# ARCHITECTURAL REVIEW COMMITTEE MEMORANDUM

SUBJECT: FLANNERY EXCHANGE LLC, OWNER, FOR A MINOR ARCHITECTURAL APPLICATION PROPOSING THE CONSTRUCTION OF METAL FRAME SHADE STRUCTURE ON THE SECOND FLOOR BALCONY, ADDITION OF AN EXTERIOR SPIRAL STAIRCASE, PERMANENT INSTALLATION ON THE SECOND FLOOR BALCONY OF AN AIRSTREAM TRAILER TO SERVE AS A BAR LOCATED AT 750 NORTH PALM CANYON DRIVE, ZONE C1/R3 (CASE # 3.3795 MAA) (RB)

**EXTERIOR OPEN STAIRS & METAL STRUCTURE @ 2nd FLOOR**  
 750 NORTH PALM CANYON DRIVE PALM SPRINGS, CA 92262  
 APN 505-503-018

**1 WEST ELEVATION**  
 1/4" = 1'-0"

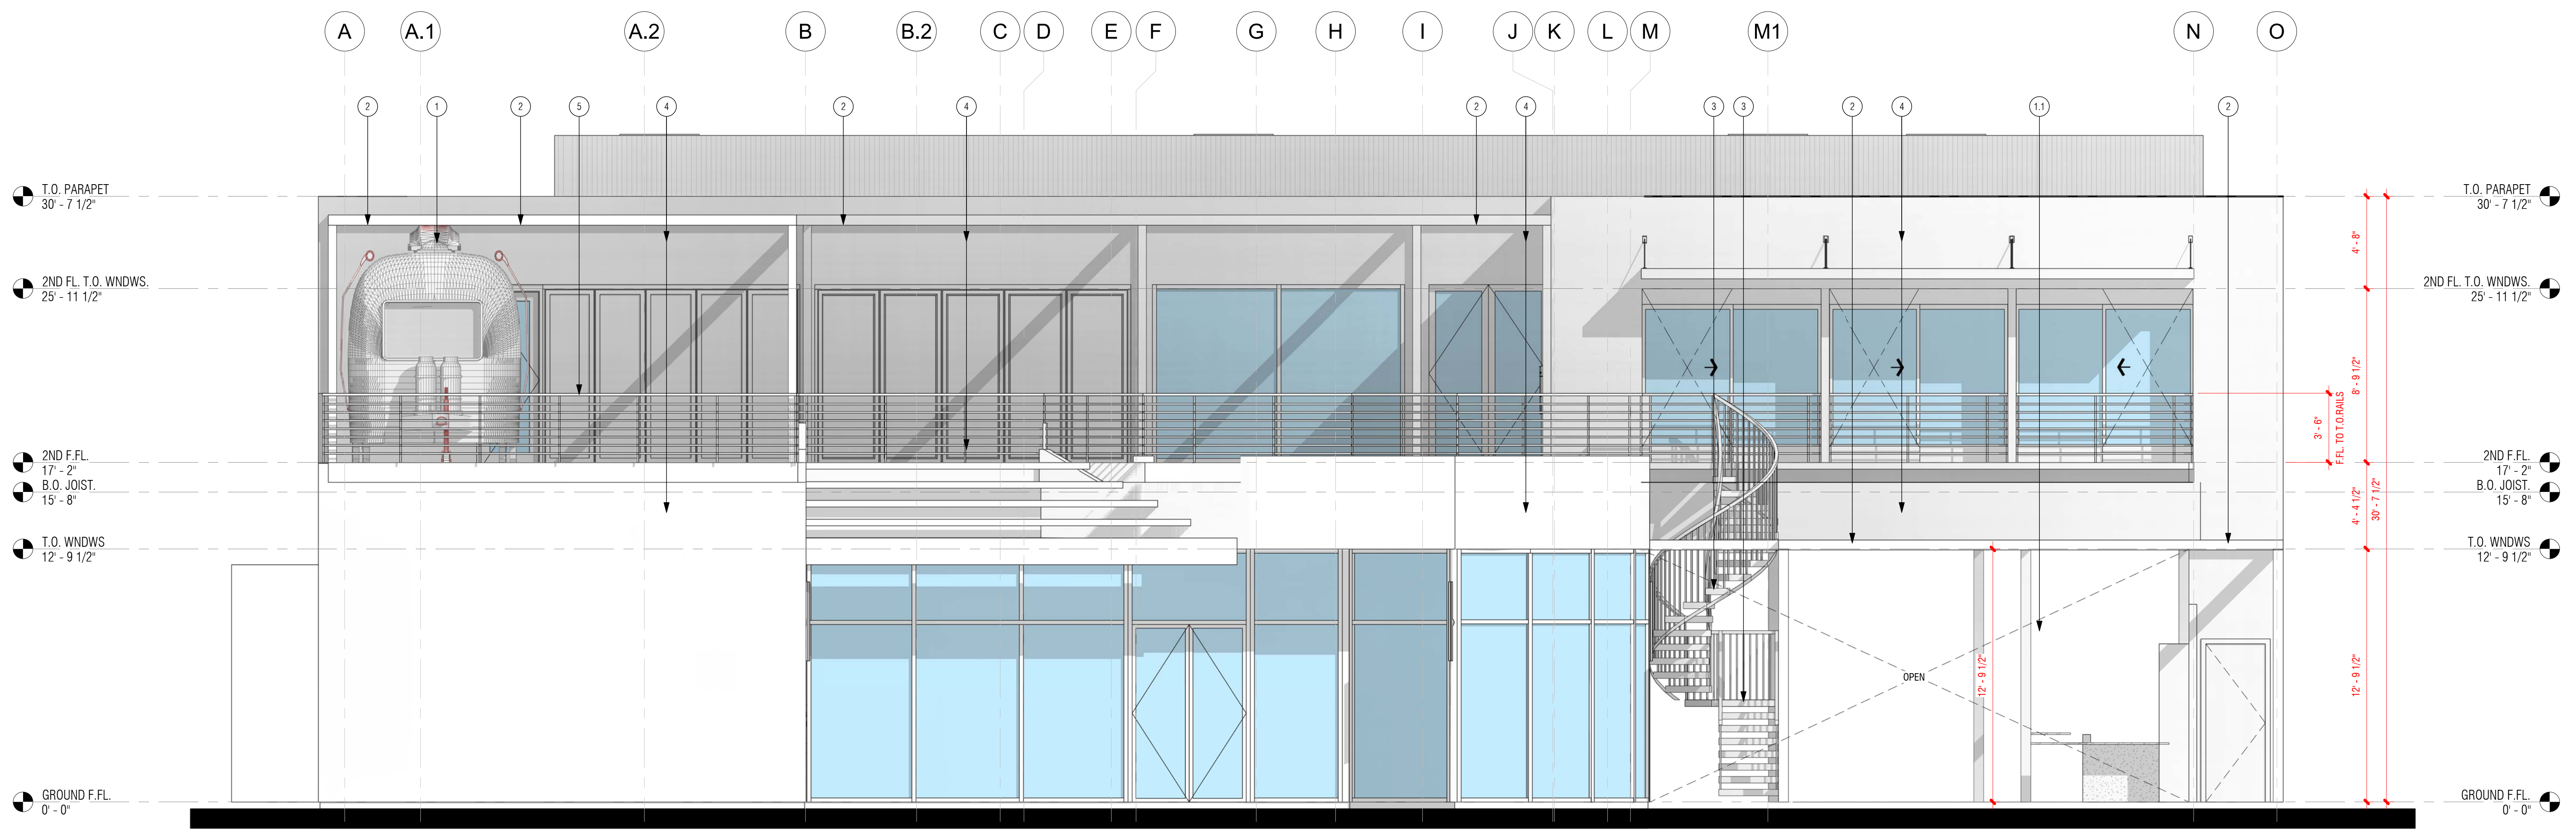
3.	<i>The façade elements and fenestration are composed in a harmonious manner;</i> The proposed Airstream trailer will be set back from the front edge facade of the second-floor patio with screening installed to further complement the street view. Staff is recommending the addition of permanent screening to improve the exterior composition.	Y with conditions

4.	<i>The proposed materials are consistent with the context of the site, adjacent buildings, and the desert environment;</i> The proposed materials will complement the existing architecture. The addition of a vegetative border along the front edge of the second-floor patio will bring a cohesive look to the surrounding environment. Staff recommends vegetative border or similar material.	Y with conditions

1. Provide adequate screening of the Airstream trailer from the north and west street view.
2. Vegetative materials to screen this recreational vehicle from public scenery.

1. Provide adequate screening of the Airstream trailer from the north and west street view sheds.
2. Vegetative materials to screen this recreational vehicle from public scenery.
